Historical Architectural Review Board
COA Preliminary Review Sheet

HDC-2025-00010

Address: 419 N 9th Street

Proposal: Window replacement at front and rear

Front windows proposed for replacement (Applicant)

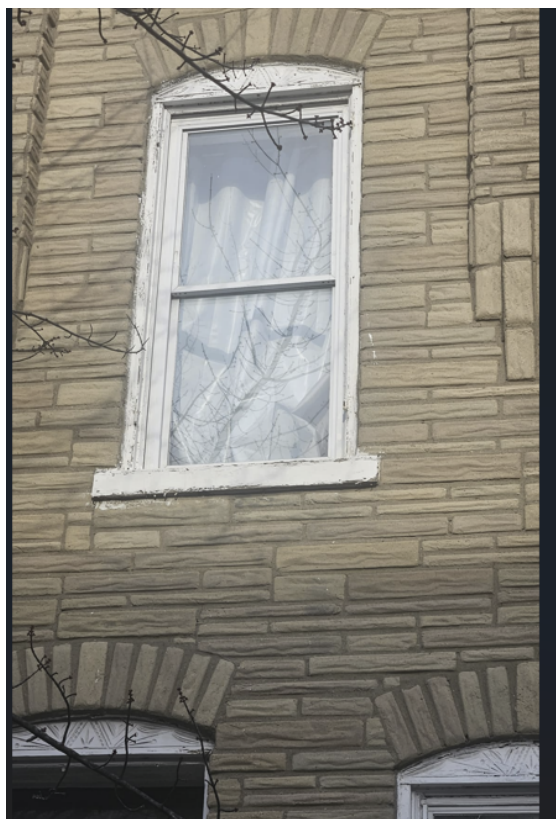
Observations & Comments: The front windows facing 9th Street are previous replacement windows. The proposed 1/1 fiberglass windows appear to be an in-kind replacement of the existing windows. The decorative carved lintels should be protected and maintained.

- Front window lintels are protected and maintained.
- Applicant clarifies placement of windows in rear later addition, showing vertical and horizontal alignment. Final placement approved by Staff.
- Applicant submits window infill material, to be approved by Staff.

- Front window lintels are protected and maintained
- Applicant submits window infill material, to be approved by Staff.
- Rear window in brick wall is not under HARB purview.
